## **ELSMOR – towards European Licensing of Small Modular Reactors: Methodology recommendations for light-water small modular reactors safety assessment**

**REVISED** **ELSMOR – towards European Licensing of Small Modular Reactors: Methodology recommendations for light-water small modular reactors safety assessment**

[version 2; peer review: 2 approved, 3 approved with reservations]

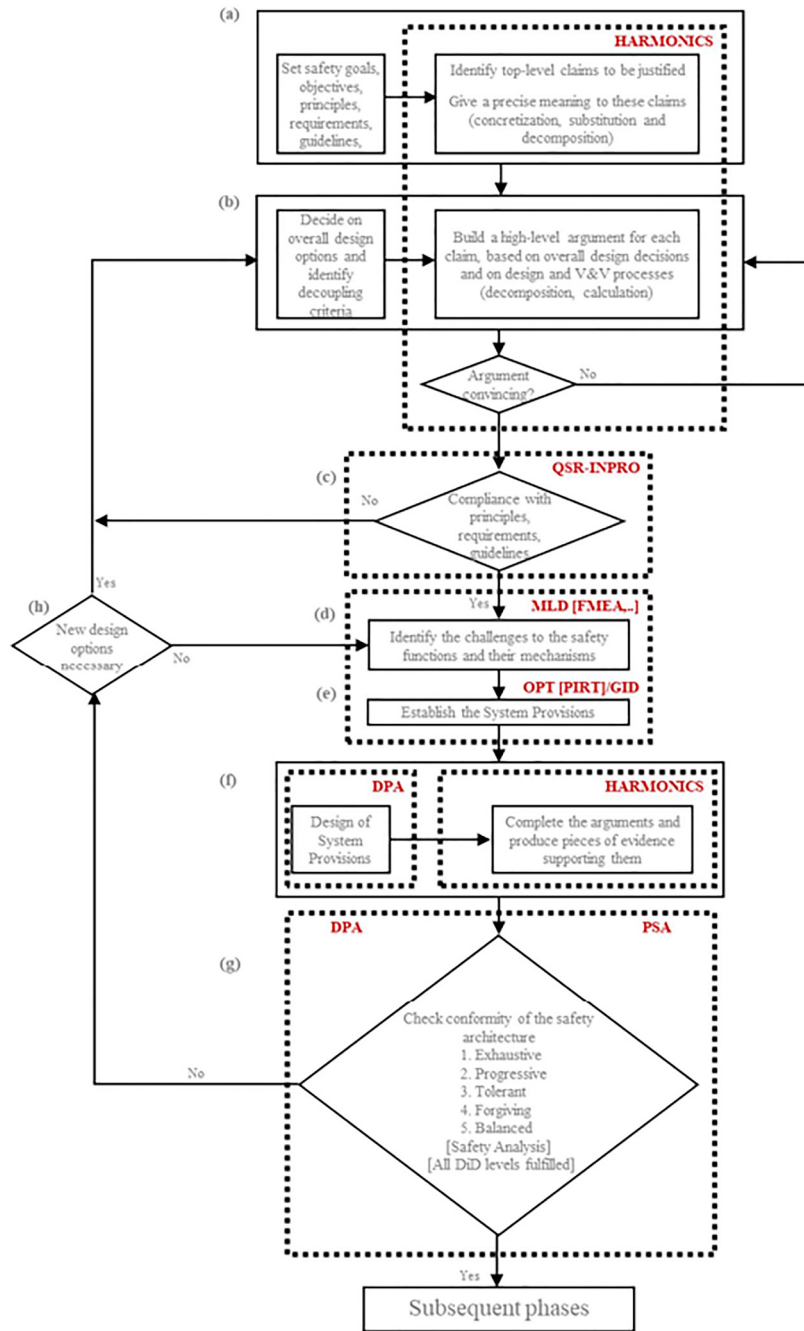
7. Analytic and probabilistic safety analyses may be mentioned in Figure.1 since a quantitative method is needed for licensing an SMR.

4. Figure 1 is simplified comparing to Figure 1 of ELSMOR deliverable D2.2, which identifies also the steps of the ELSMOR methodology and the review methodologies (e.g. HARMONICS, QSR, PIRT, GID). The Open Letter has section 'Recommendations related to high-level safety methodologies used for a licensing', but later very few review methods are mentioned (e.g. ISAM is exception). Consider to provide some information or at least references for the review methodologies.

Figure 1 was updated to include further details on methods considered to develop the algorithm.

6. The modularity term will be clarified in the paragraph "Recommendations related to high-level safety methodologies used for a licensing"
7. The Figure was changed for a more complete one, which includes, in particular, references to PSA methods.

4. A description of the methodologies reviewed (ISAM, INPRO, SARGEN\_IV, HARMONICS) and used for the development of the ELSMOR safety assessment methodology has been added in the text of the article. References of the reviewed methodologies and the description of their content are described in ELSMOR Deliverable 2.2 to which a cross-link has been added in the text.
